PRODUCT/PROCESS CHANGE NOTICE (PCN)

PCN #: TB-0510-05	DATE: 14-Dec-2005	MEANS OF DISTINGUISHING CHANGED DEVICES:
Product Affected: 48L, 56L, 64L TSSOP & 80L TVSOP & 48L, 56L TSSOP exposed pad (Green & Standard)		☐ Product Mark ☐ Back Mark ☐ Date Code ☒ Other
Date Effective: 13-Jan-2006		Rev 07 printed on shipping tube

ATTACHMENT I - PCN #: TB-0510-05

Existing Shipping Tube

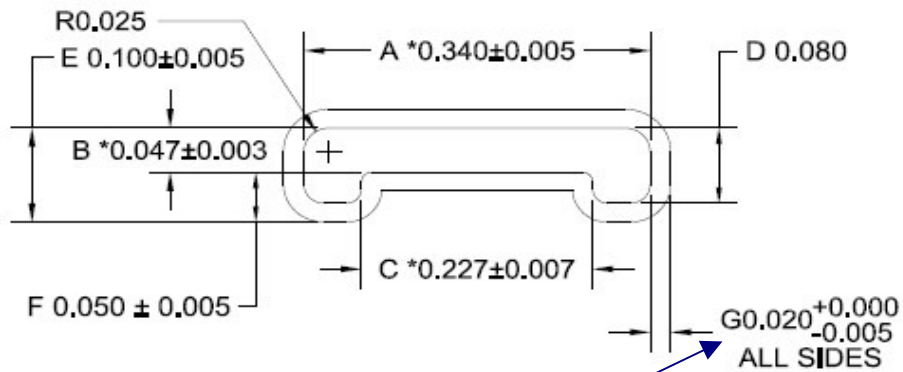
Existing Tube – wall thickness : 0.015 to 0.020

Existing Tube – printed revision, REV.06

New Shipping Tube

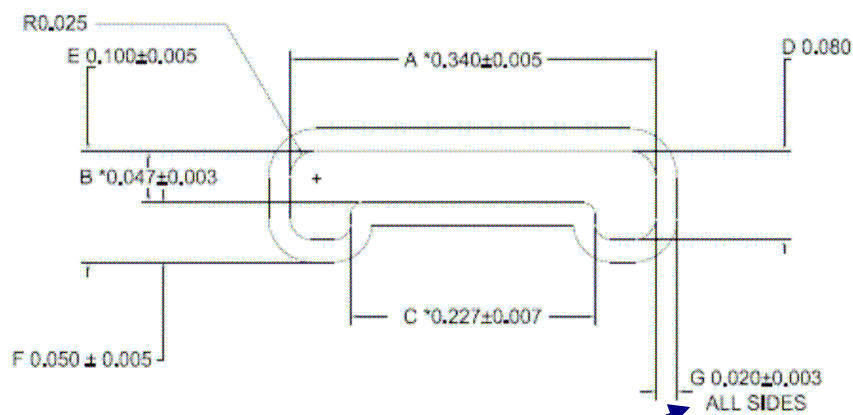
New Tube – wall thickness : 0.017 to 0.023

New Tube – printed revision, REV.07
